CITY OF WESTMINSTER			
PLANNING APPLICATIONS COMMITTEE	Date 25 April 2017	Classification For General Release	
Report of Director of Planning		Ward(s) involved Little Venice	
Subject of Report	283 - 329 Edgware Road and 5 Newcastle Place, London, W2 1DH		
Proposal	Variation of Condition 1 of the planning permission granted 27 January 2017 (ref: 16/07226/FULL) for a redevelopment to provide buildings of between ground + 6 and ground + 29 storeys including commercial space (Class A1, A2, A3, A4 and B1), up to 672 residential units (including 130 affordable housing units), landscaping and associated car and cycle parking. NAMELY, amendment to the façade of Block A, and ground floor arrangement of Block A including residential drop off and ancillary residential uses, with associated amendment to landscaping plan.		
Agent	Turley		
On behalf of	Berkeley Homes (Central London) Ltd		
Registered Number	16/12162/FULL	Date amended/ completed	27 January 2017

1. RECOMMENDATION

Approved (top) and Proposed (bottom) Plans and Visuals of the Vehicle Drop Off Areas

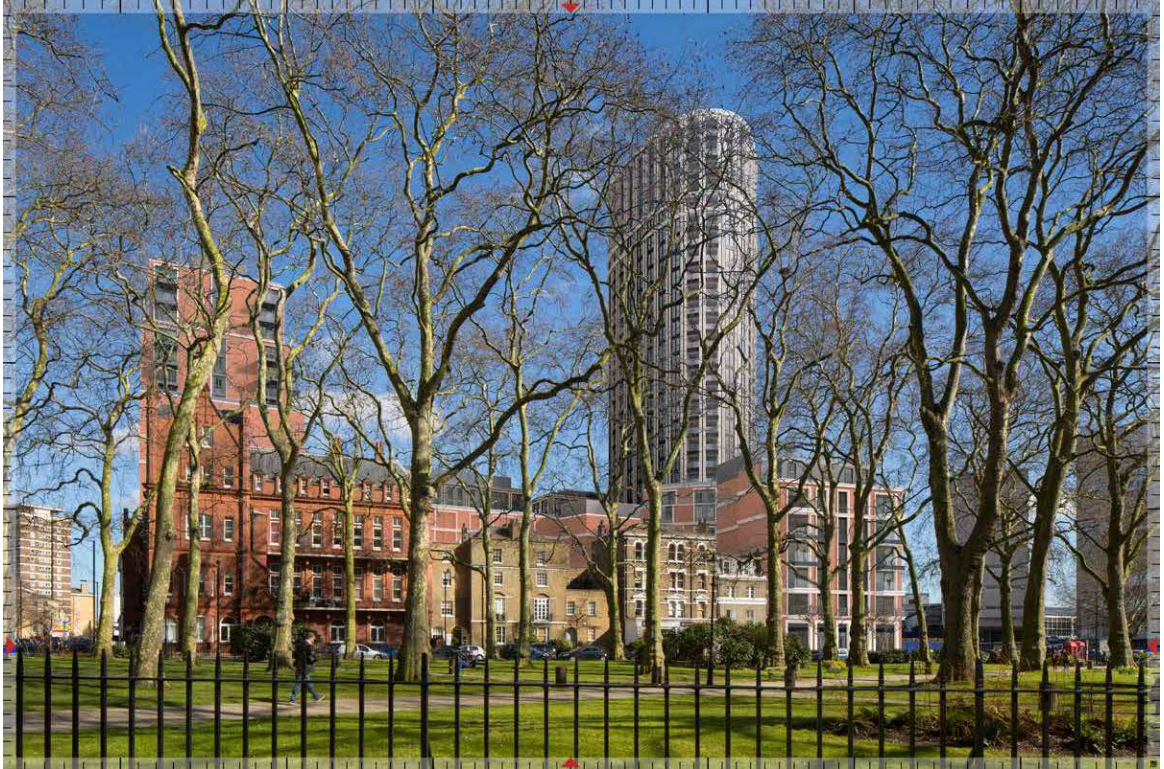
The area to the north side of Block A was described as being a 'Plaza' on the approved drawings, and conceived as a quieter more pedestrian focussed route in contrast to Newcastle Place on the south side of Block A. Whilst the increase in traffic around the northern side of the tower is to an extent to be regretted, it will nonetheless provide some greater animation of this part of the site which is set away from the public road of Newcastle Place and not on a direct route through the site. The approach would not unduly compromise the public realm around Block A and is considered acceptable.

Enclosure of the porte-cochere area would allow for a more continuous frontage to Newcastle Place and a greater degree of visual solidity to the base of the tower at this point. It would also provide a greater animation of the street scene given the gym use shown to the plans as being within this area. The pedestrian environment along Newcastle Place would also be improved through the removal of associated vehicular cross-over points to allow for accessing and exiting the porte-cochere.

The new drop-off area would include a canopy structure. This canopy is considered light weight and neatly detailed and incorporates bronze aluminium supporting fins which will sit comfortably with the appearance of Block A. It will provide some definition to the entrance into this large residential block and is considered appropriate.

The Highways Planning Manager has reviewed the proposal. He has no objection to moving the residential drop-off from the south to the north of the building as it utilises existing crossovers permitted under the original permission.

However, the new servicing bay proposed would reduce the footway width to virtually nothing on part of Newcastle Place. This servicing bay appears to also not be necessary given the width of Newcastle Place and the absence of any restrictions on on-street servicing. Accordingly, the Highways Planning Manager has requested removal of this servicing bay and the Committee will be updated verbally with the outcome of this request,
